**Addendum No. 1**  
**August 24, 2022**

Project name: Health Sciences Surgical Simulation Suite Renovation  
University of South Dakota  
Sanford School of Medicine  
OSE #R0622—05X  
Architecture Incorporated Project #:0217.2984.22

Scope of this Addendum:

**7.10**

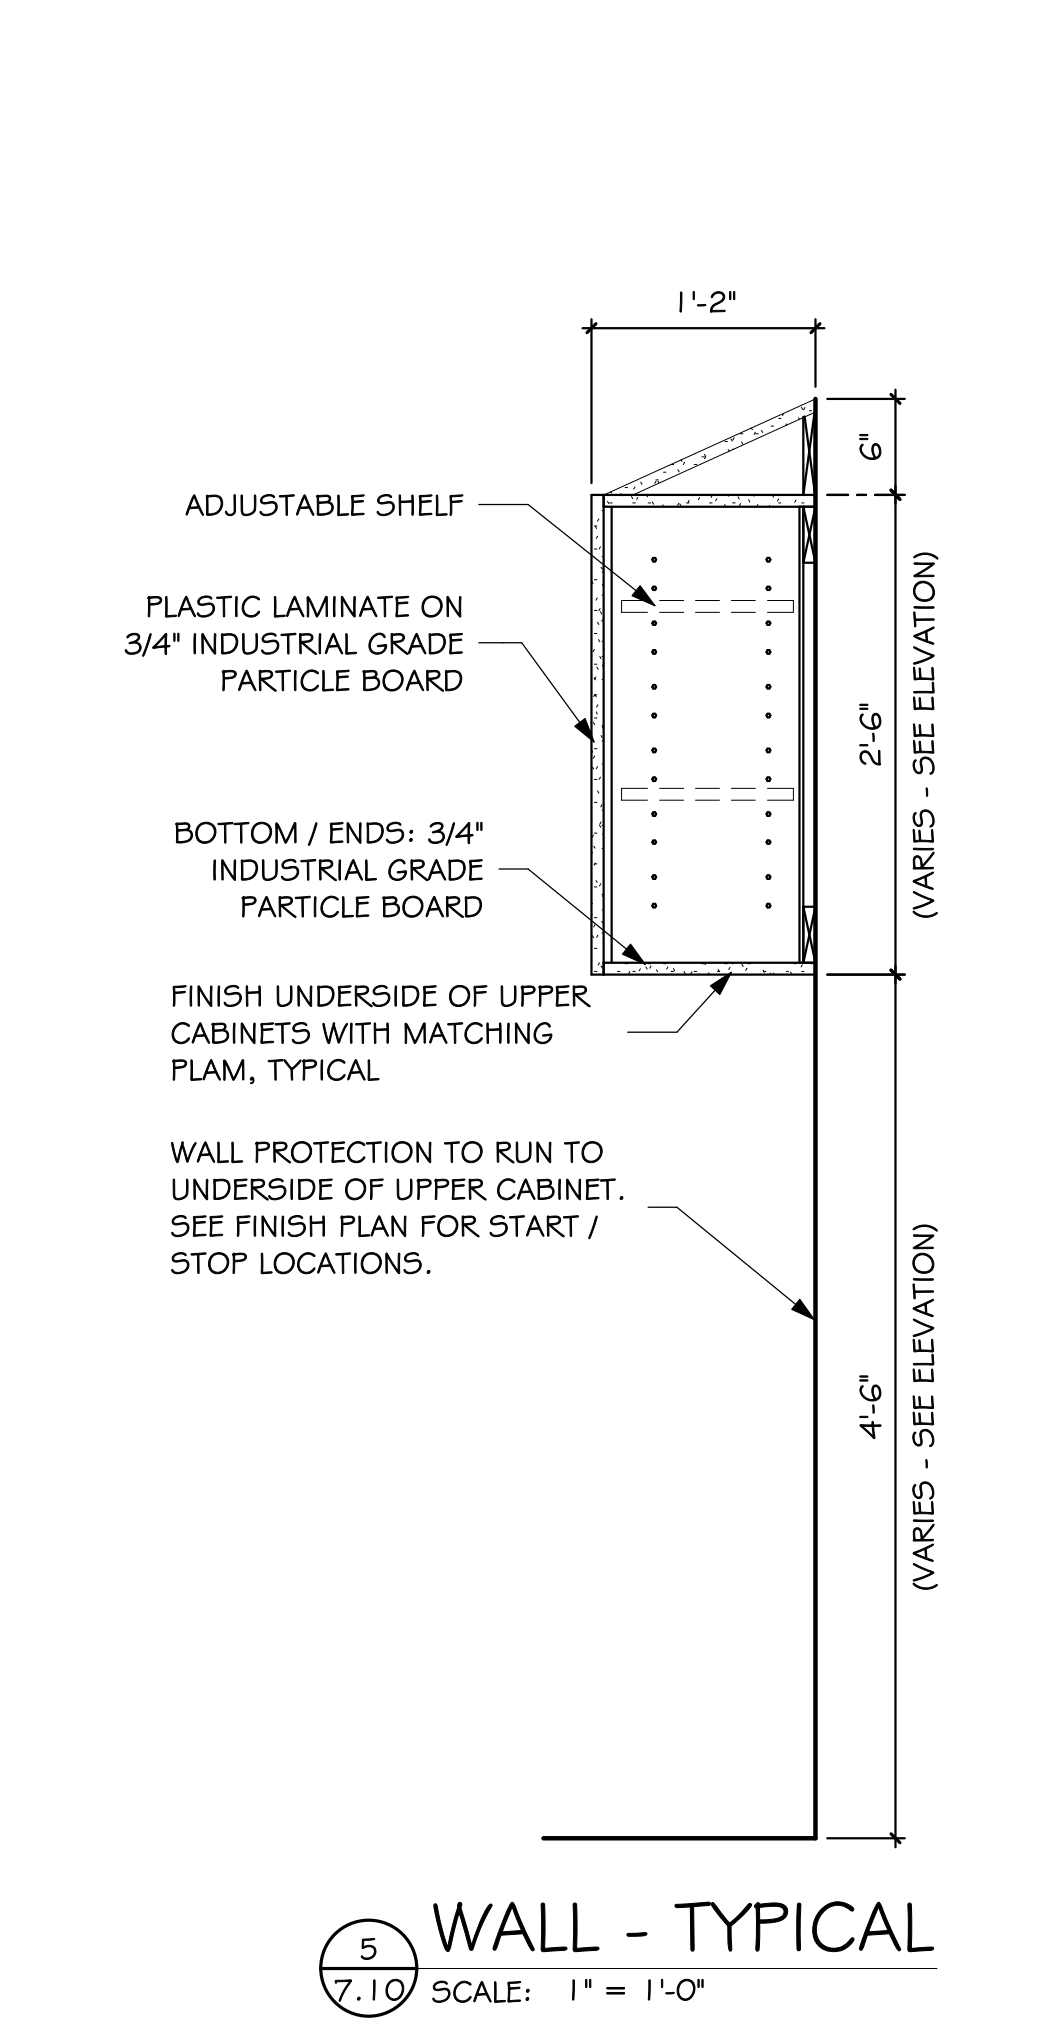
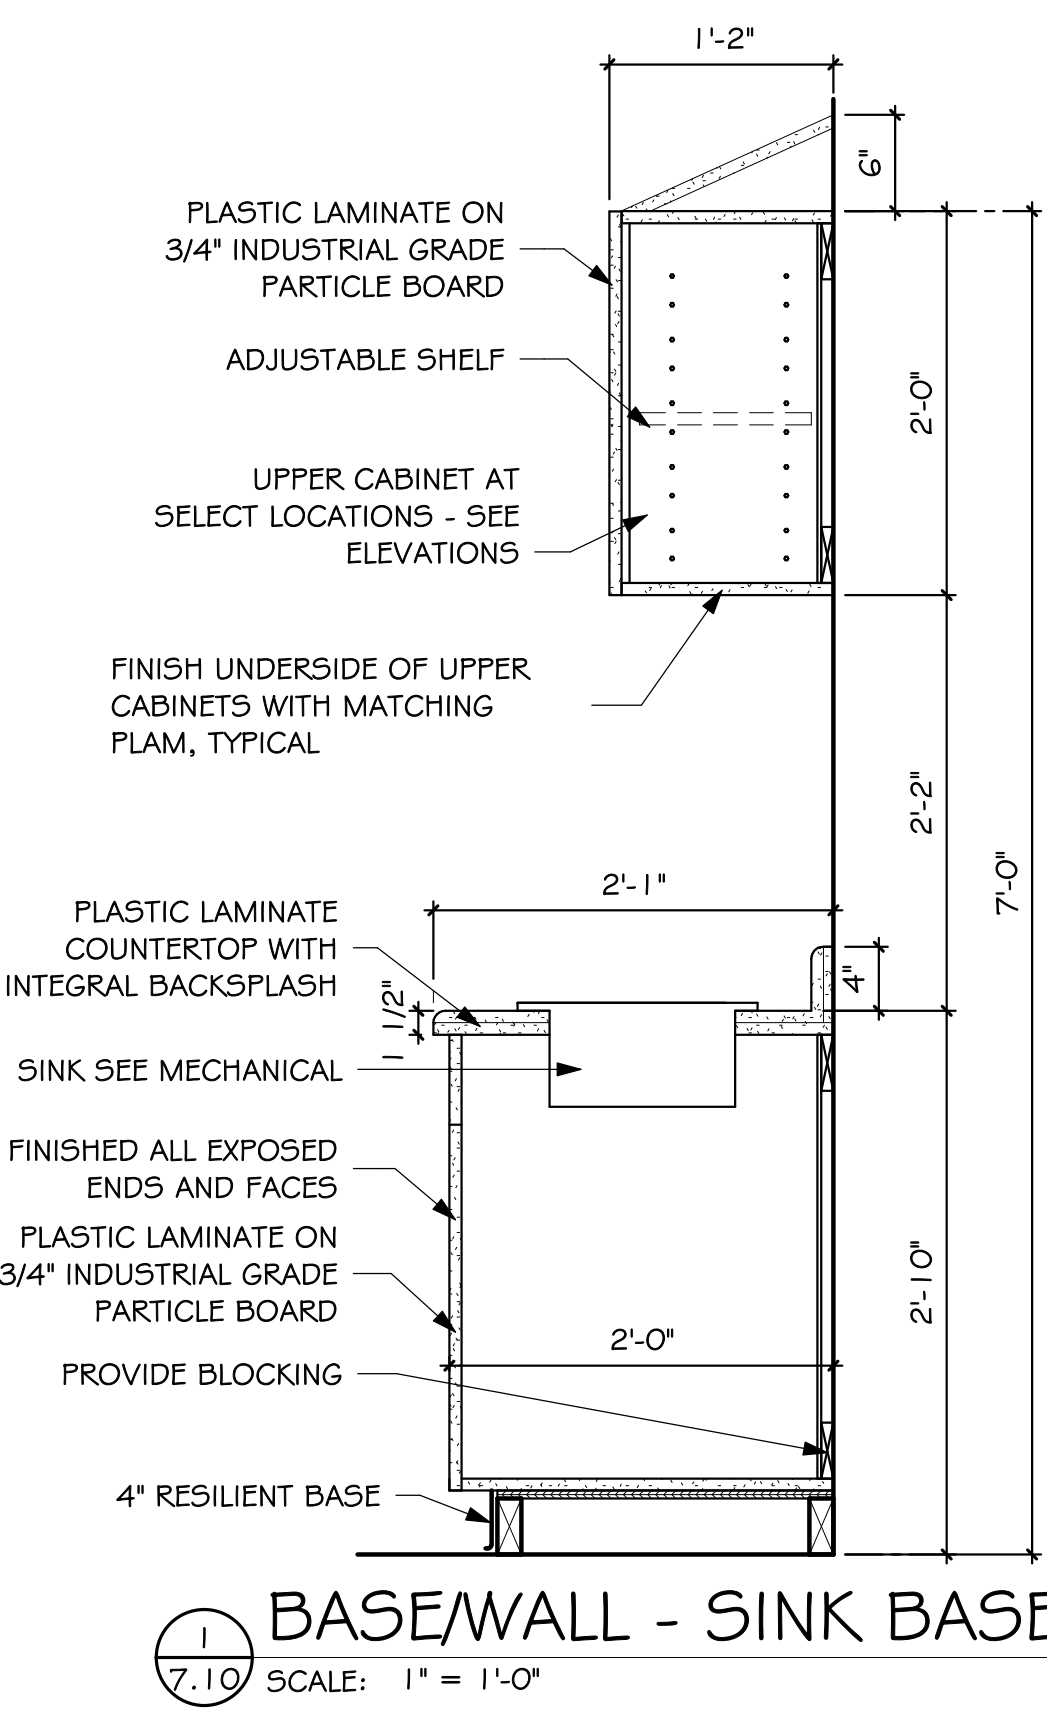
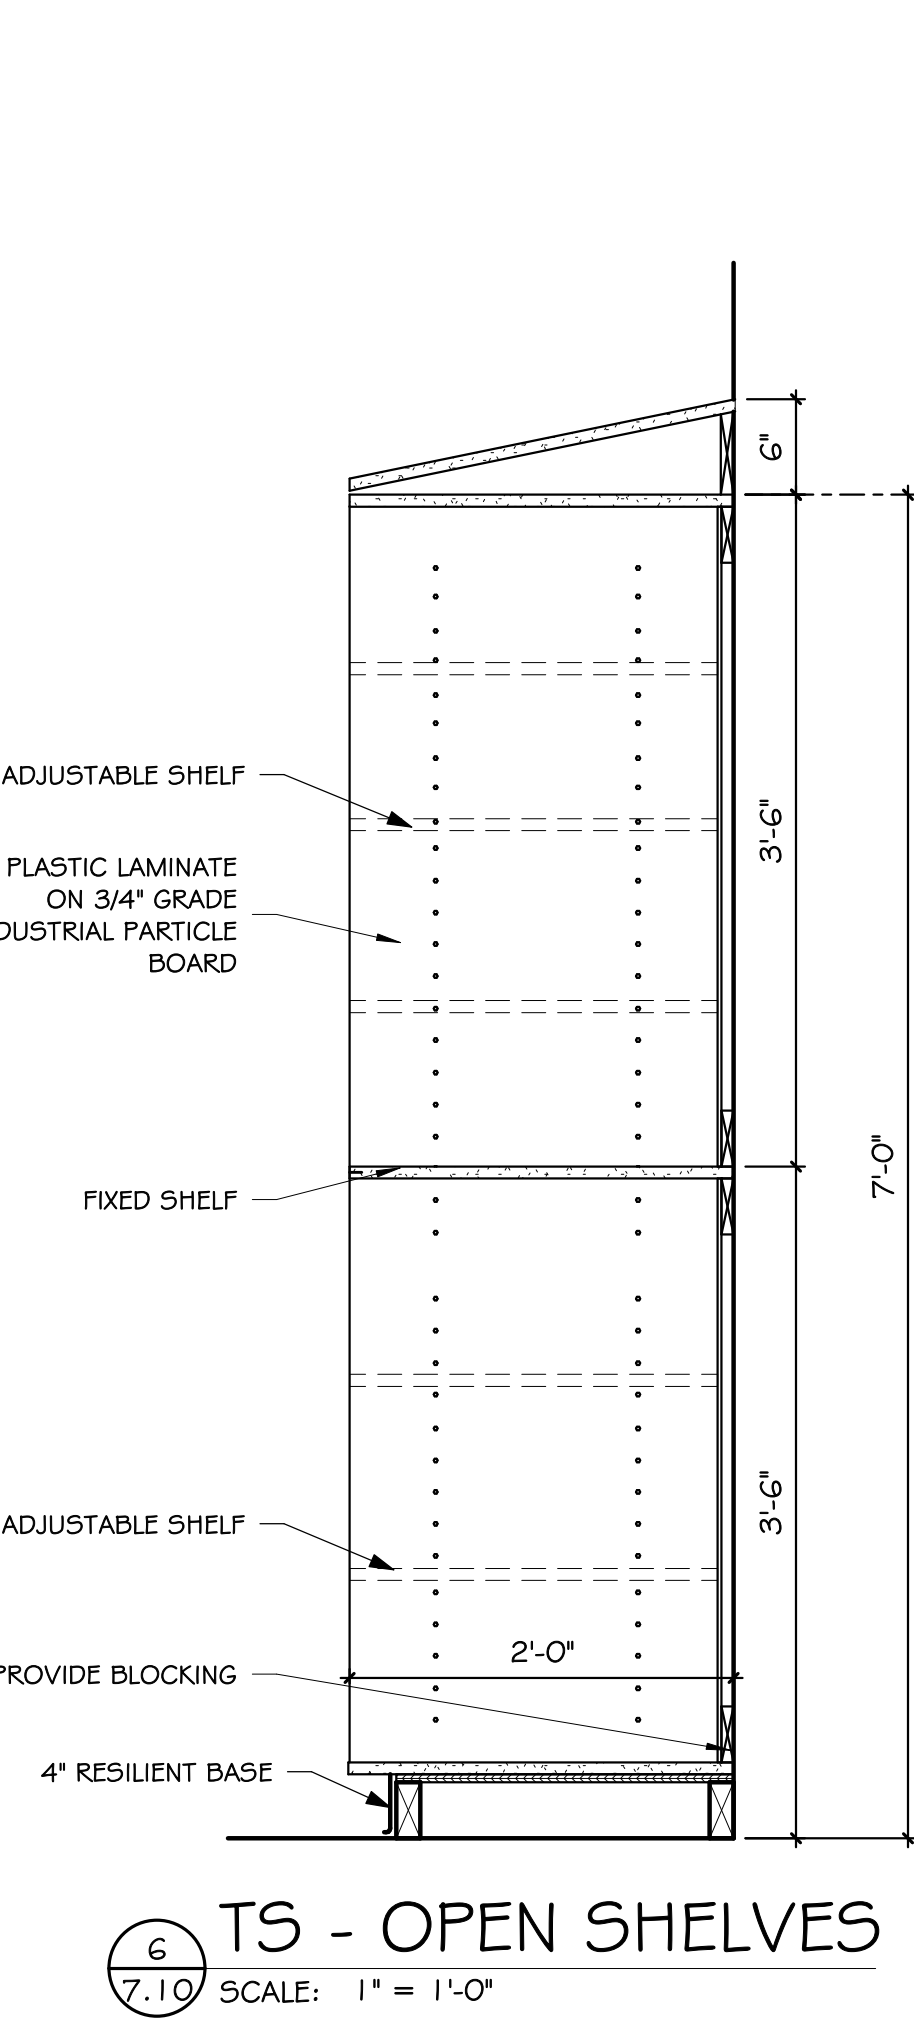
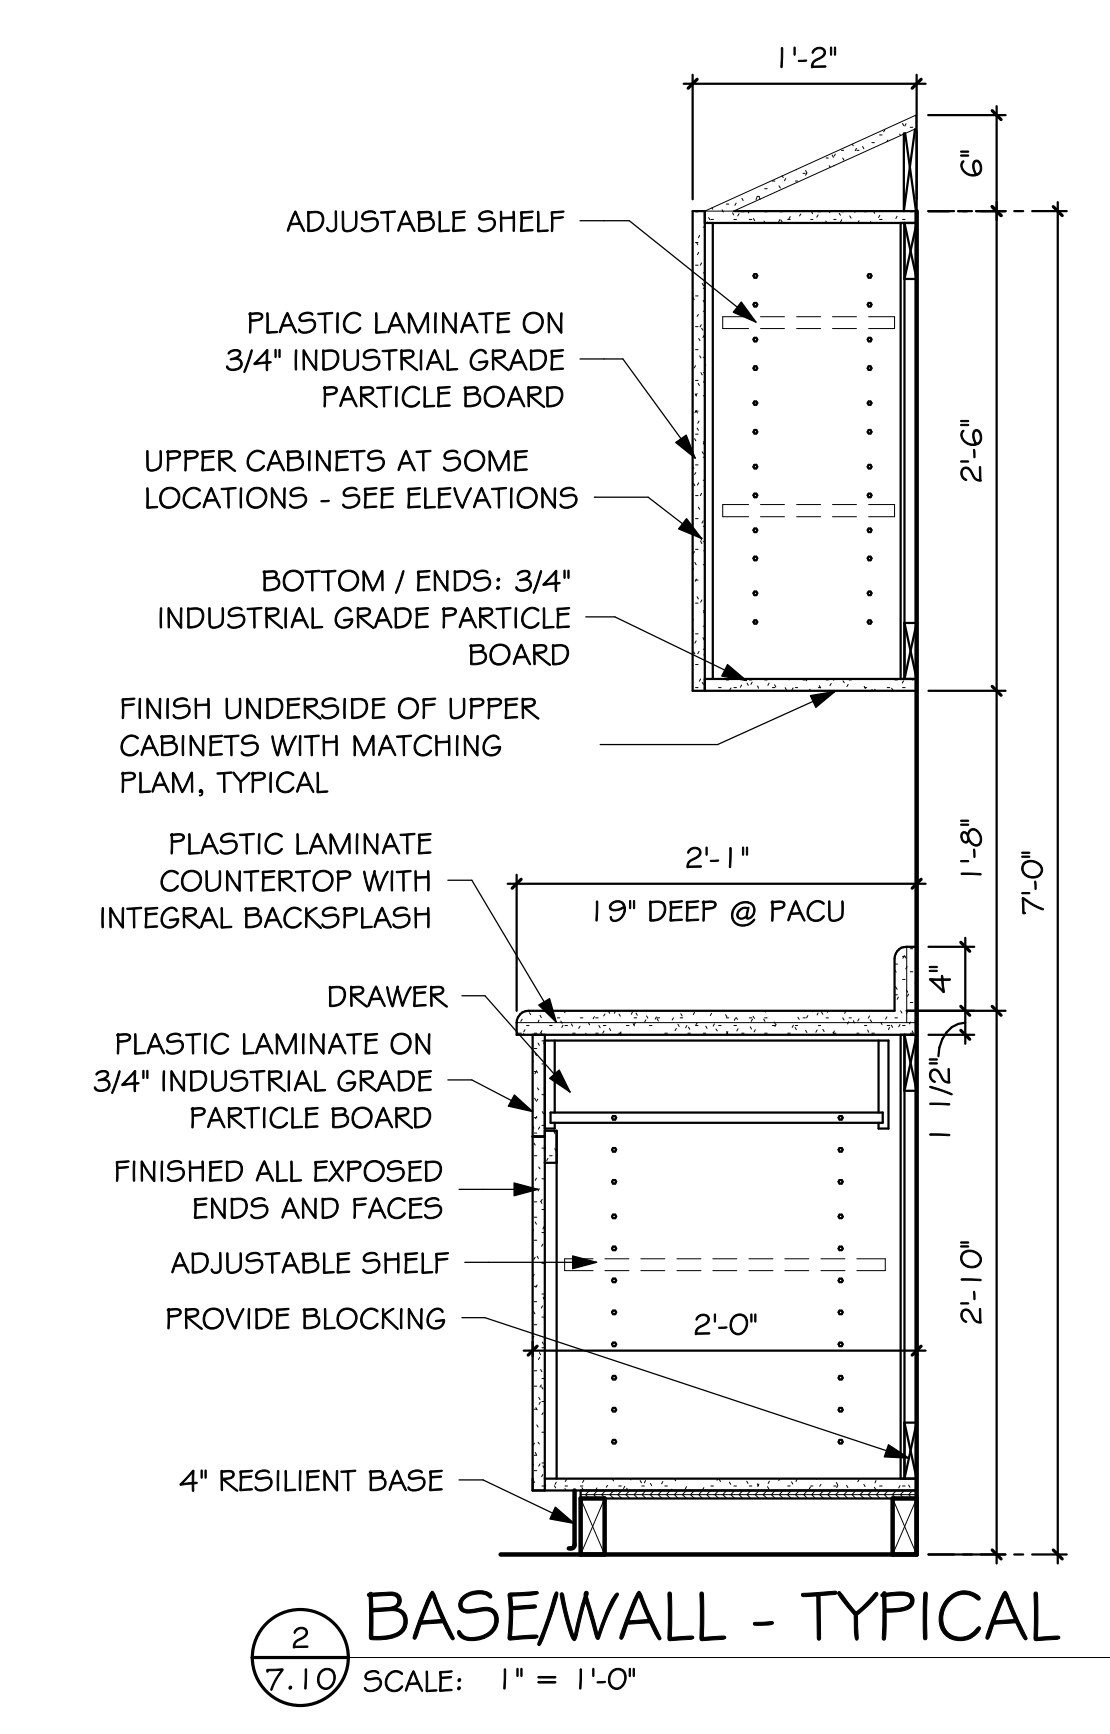
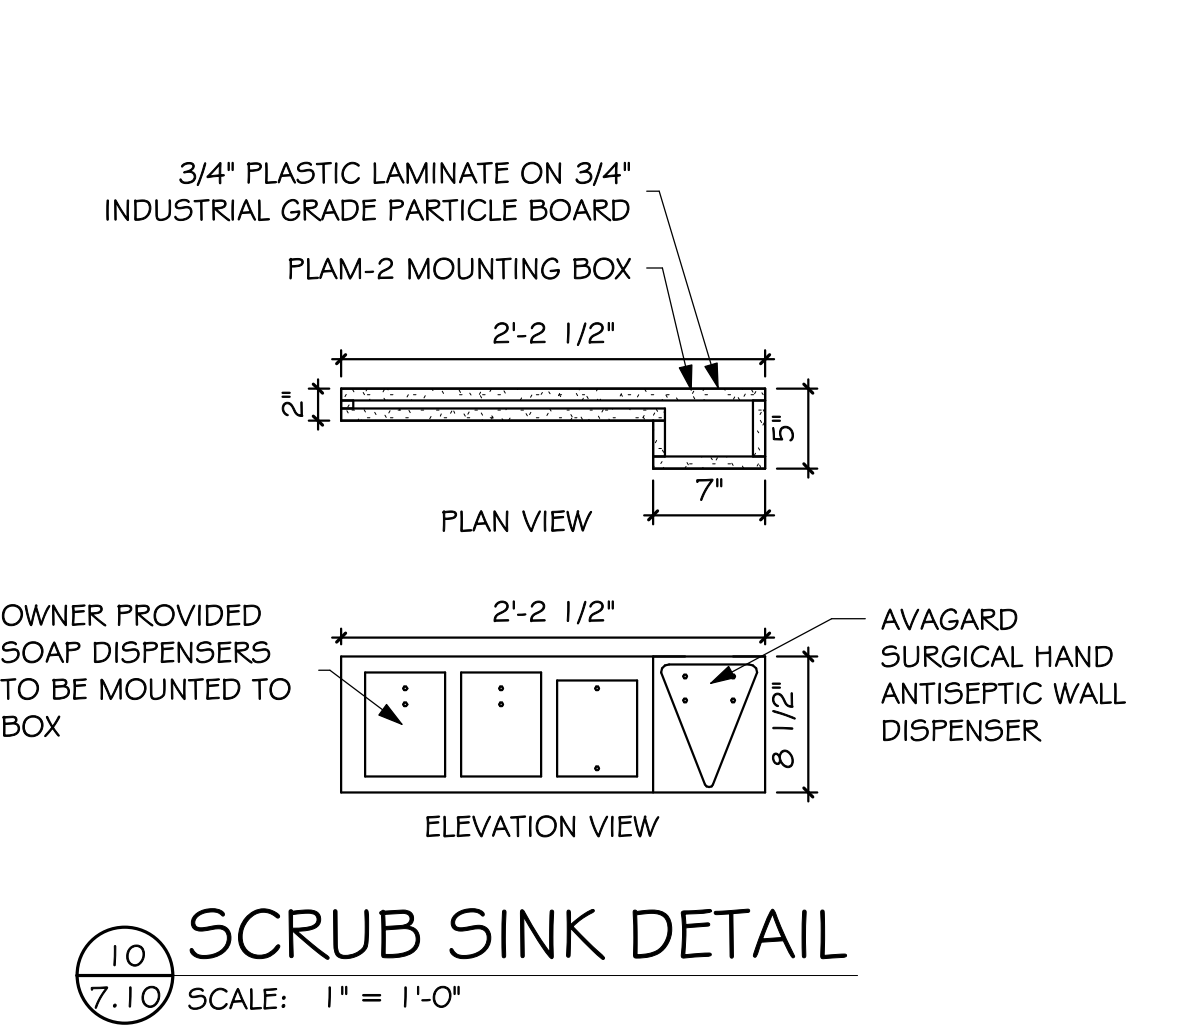
4) DRAWING 7.10 – CASEWORK SECTIONS

- a) Detail 3/1.10 – Tall Storage – High Shelf
  - i) Omit note for Kaba punch lock. Kaba punch locks were eliminated from the project.
